Idle Relief Restriction – 75 thru 250 Hp

Mariner/Mercury 75 thru 250 HP

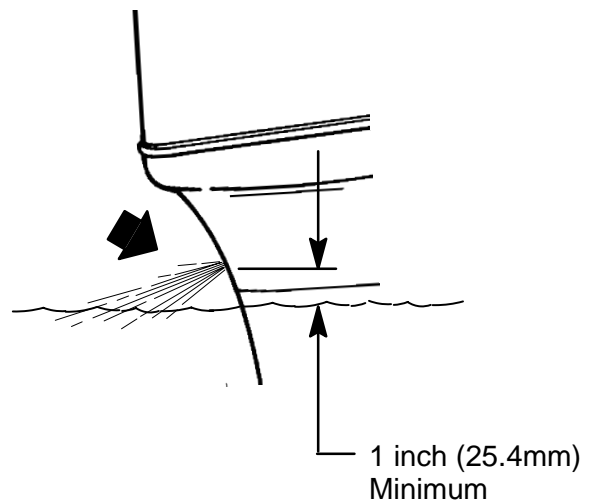
Poor engine performance may be caused by submersion of the exhaust relief hole. Submerging the idle relief hole can cause an exhaust restriction that may cause poor acceleration, poor idle, excessive smoke, and fouled spark plugs.

Outboards installed too low on the transom can ingest water and cause engine damage which is not covered by warranty.

When installing the outboard, the idle relief hole should be at least 1 inch (25.4mm) above the water line when the boat is fully loaded and at rest or at idle speed, with the outboard trimmed in.

Trimming the outboard out at idle speed may help keep the idle relief hole above the water. This may be necessary on boats where the outboard cannot be raised. However, the outboard will have to be lowered for accelerating from a standing start or from idle speed.
